HIGH AFT CROSSTUBE

FIGURE 1

Airworthiness Directives; Boeing Model 777 Series Airplanes

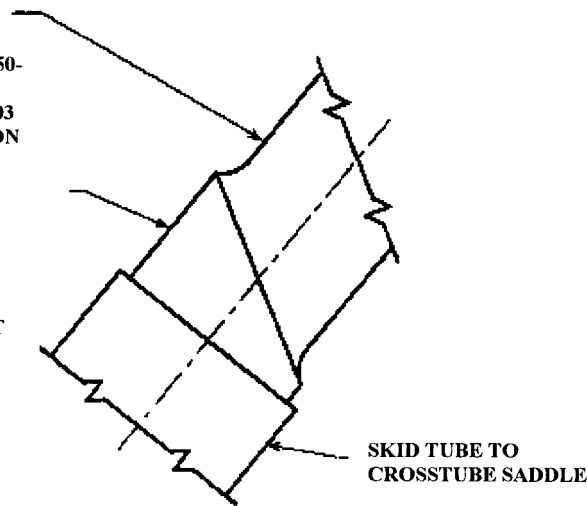
THE FACTORY HAS INK
STAMPED THE SUBASSEMBLY
AND SYNTHETIC P/N 412-050-
044-101, -101A, OR -103 IN THIS
GENERAL AREA.

CROSSTUBE ASSEMBLY P/N 412-050-
045-107 HAS THE NEXT LOWER
(SUBASSEMBLY) P/N 412-050-044-103
VIBRO-ETCHED IN THIS LOCATION
FROM THE FACTORY. THE S/N IS
POSITIONED UNDER THE P/N.

VIBRO-ETCH 412-050-011-107 FM
AND A COMPANY CONTROLLED
S/N IN THIS AREA AS REQUIRED
TO TRACK REMAINING HIGH AFT
CROSSTUBE LIFE. VIBRO-
ETCHING DEPTH SHALL NOT
EXCEED 0.005 INCH.

(b) For a crosstube assembly, P/N 412-050-010-101 or 412-050-011-107 FM, on or before accumulating 10,000 landings or within 25 hours TIS after the effective date of this AD, whichever occurs later, replace the crosstube assembly with an airworthy crosstube assembly.

(c) For a crosstube assembly, P/N 412-050-045-107, on or before accumulating 20,000 landings or within 25 hours TIS after the effective date of this AD, whichever occurs later, replace the crosstube assembly with an airworthy crosstube assembly.

(d) This AD revises the Airworthiness Limitations section of the Maintenance Manual by establishing a life limit of 10,000 landings for the crosstube assembly, P/N 412-050-010-101 and 412-050-011-107 FM, and 20,000 landings for the crosstube assembly, P/N 412-050-045-107.
